UNITED STATES PATENT AND TRADEMARK OFFICE

APPLICATION NO.	FILING DATE	FIRST NAMED INVENTOR	ATTORNEY DOCKET NO.	CONFIRMATION NO.
10/025,902	12/26/2001	Hong-Man Moon	8733.559.00	7628
30827	7590	03/09/2004	EXAMINER	
MCKENNA LONG & ALDRIDGE LLP 1900 K STREET, NW WASHINGTON, DC 20006			RUDE, TIMOTHY L	
			ART UNIT	PAPER NUMBER

Office Action Summary

DETAILED ACTION

FIG. 3

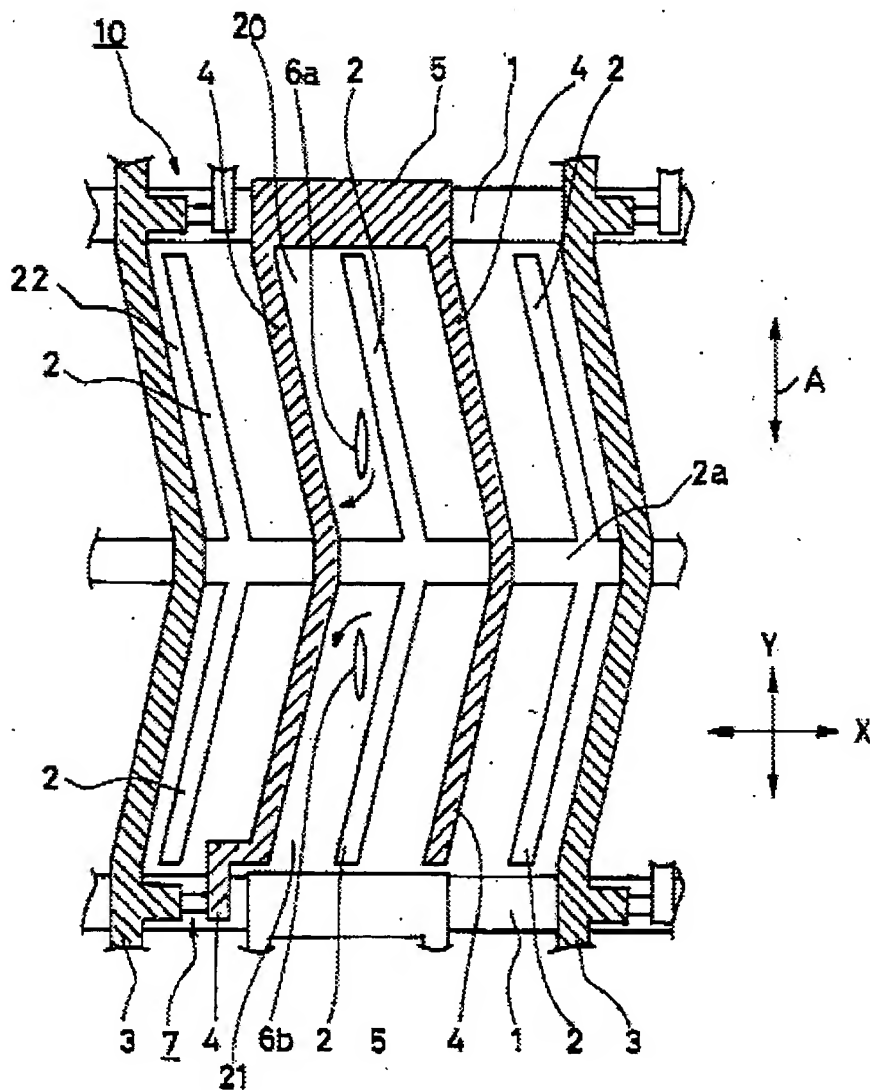
As to claim 1, Asada discloses in Figure 3, second embodiment, (col. 6, line 55 through col. 7, line 5) that is a variation of the first embodiment (col. 4, line 58 through col. 6, line 54) an in-plane switching liquid crystal display device, comprising:

- first and second substrates;
- a scanning wiring, 1 (Applicant's gate line), and a signal wiring, 3 (Applicant's data line), defining a pixel region on the first substrate;
- a common line, 2a, on the middle of the pixel region;
- a thin film transistor, 7, at a crossing portion of the gate and data lines, the thin film transistor having gate, source, and drain electrodes;
- a first insulating layer on the gate line;
- a plurality of transparent common electrodes, 2 (center electrodes, top and bottom), on the first substrate;
- a plurality of transparent pixel electrodes, 4 (right electrodes, top and bottom), on the first substrate;

at least one extended portion, 2 (common electrodes on left and right, top and bottom, near data lines) extending from the common line at a boundary of the pixel region, and

a liquid crystal layer between the first and second substrates (Abstract and Summary).

As to claim 2, Asada discloses the device of claim 1, wherein the common electrode is connected to the common line per center of Figure 3.

As to claim 7, Asada discloses the device of claim 1, wherein the pixel region is divided by the common line per Figure 3.

As to claim 8, Asada discloses the device of claim 1, further comprising an overlap (vertical portions of pixel electrodes) of the pixel electrodes over the common line (Applicant's first storage electrode on the first insulating layer over the common line) per Figure 3.

As to claim 9, Asada discloses the device of claim 8, wherein said first storage electrode is connected to the switching device, 7 (Applicant's drain electrode), per Figure 3.

As to claim 10, Asada discloses the device of claim 1, further comprising capacitive accumulation portions, 5 (Applicant's second storage electrode) on the first insulating layer over the gate line per Figure 3.

As to claim 11, Asada discloses the device of claim 10, wherein the second storage electrode, 5, is connected to the pixel electrode, 4, per Figure 3.

As to claim 13, Asada discloses the device of claim 1, wherein the extended portion is substantially perpendicular to the common line (runs generally up and down rather than left to right in Figure 3).

As to claim 16, Asada discloses the device of claim 14, further comprising an overlap (vertical portions of pixel electrodes) of the pixel electrodes over the common line (Applicant's first storage electrode on the first insulating layer) per Figure 3.

As to claim 17, Asada discloses the device of claim 16, wherein said first storage electrode is over the common line per Figure 3.

FIG. 20

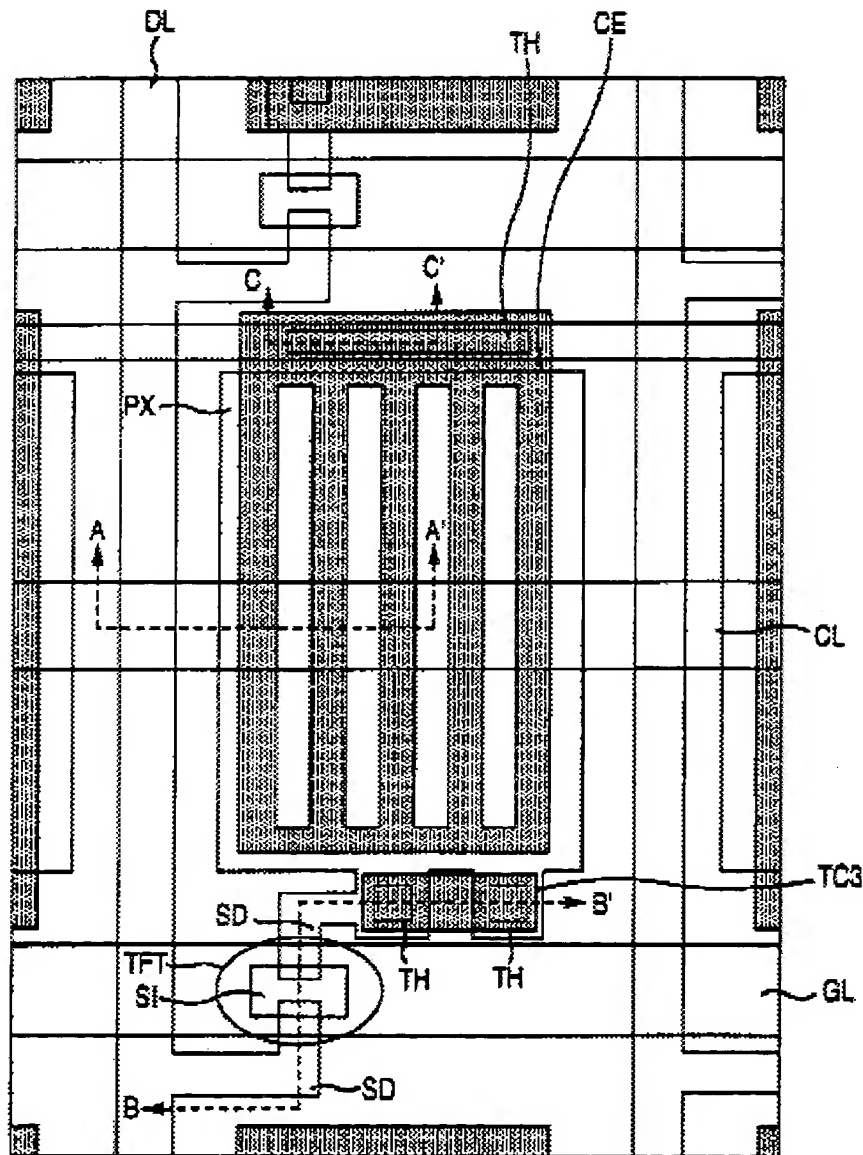
Abe teaches in his third embodiment, Figures 20 and 22, (col. 30, lines 1-65) the use of a transverse common electrode (left to right portion of CE) over the common line wherein the transverse common electrode contacts the common line through at least one contact hole (TH) in his design to reduce required driving voltage.

Abe is evidence that ordinary workers in the art of liquid crystals would find the reason, suggestion, or motivation to add a transverse common electrode over the common line wherein the transverse common electrode contacts the common line through at least one contact hole in his design to reduce required driving voltage.

Therefore, it would have been obvious to one having ordinary skill in the art of liquid crystals at the time the invention was made to modify the LCD of Asada with the transverse common electrode over the common line wherein the transverse common electrode contacts the common line through at least one contact hole of Abe to reduce required driving voltage.
